# Access Compliance Report

## Public Rights-of-Way

Intersection ID: 22578	Main Street: MAGNOLIA_BRIDGE_RD	Cross Street: QUAIL_HOLLOW_RD	Location: SE
ADA ID: 80F553EE283B	Ramp Type: PerpDiag	Initial Pass/Fail: Fail	Overall Compliance: No
			Severity Score: 33.75

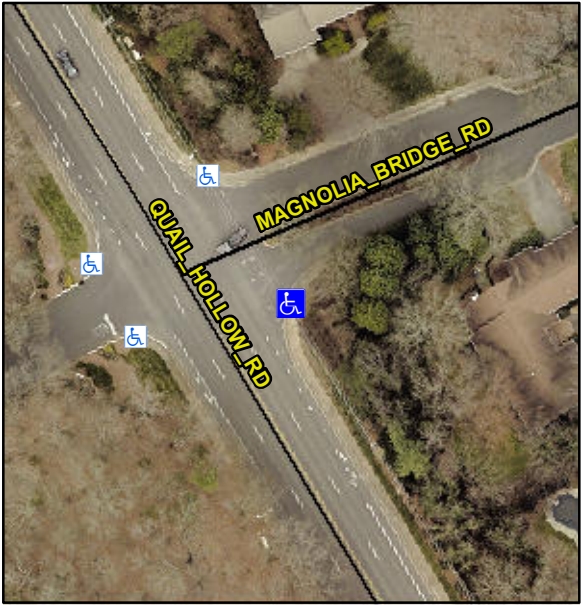
Codes/Mitigation Info/Possible Solution		Field Measurements/Component Compliance					
	Possible Solutions:	Compliance	Description	Data	Compliance	Description	Data
	Remove & Replace Curb Ramp With Two New Directional Ramps or Equivalent.	N/A	Ramp Length (in)	62.0	Yes	Ramp Slope (%)	6.0
		No	Ramp Width (in)	38.0	No	Ramp XSlope (%)	13.3
		N/A	Flare Type LT	N/A	N/A	Flare Type RT	N/A
		N/A	Flare Slope LT (%)	N/A	N/A	Flare Slope RT (%)	N/A
		N/A	Flare Traversable LT?	N/A	N/A	Flare Traversable RT?	N/A
		N/A	Landing Length (in)	N/A	N/A	DWS Provided?	N/A
		N/A	Landing Width (in)	N/A	N/A	DWS Contrast?	N/A
		N/A	Landing Slope (%)	N/A	N/A	DWS Length (in)	N/A
		N/A	Landing X Slope (%)	N/A	N/A	DWS Full Width?	N/A
		N/A	Landing Curb? (Y/N)	N/A	N/A	DWS Offset (in)	N/A
		N/A	Shared Landing?	N/A			
		N/A	Gutter Ponding?	N/A	N/A	Gutter Slope (%)	N/A
		N/A	Gutter Lip Ht (in)	N/A	N/A	Gutter X Slope (%)	N/A
		N/A	Painted X Walk1?	No	N/A	Painted X Walk2?	No

X Walk 1 Direction	To NW		X Walk 2 Direction	To W
		N/A	X Walk 1 Width (in)	N/A	N/A	X Walk 2 Width (in)	N/A
			X Walk 1 Slope (%)	0.8		X Walk 2 Slope (%)	7.8
			X Walk 1 X Slope (%)	7.7		X Walk 2 X Slope (%)	1.6
		N/A	Ramp inside XWalk1?	N/A	N/A	Ramp inside XWalk2?	N/A
<p>Surveyor Notes:</p> <p>N/A</p> <p>PROW/ADA:</p> <p>Not Found, R304.5.1, R304.5.3</p>			Road Slope (%)	7.3	N/A	Clear Space?	N/A
			Road X Slope (%)	6.0	N/A	Clear Space to XWalk (in)	N/A
		N/A	Any Obstructions?	N/A	N/A	Storm Grate/Utility Hazard?	N/A
			Obstruction Type			Storm Grate/Utility Type	
					N/A		N/A
					Yes	Surface Condition? (G/P)	Good
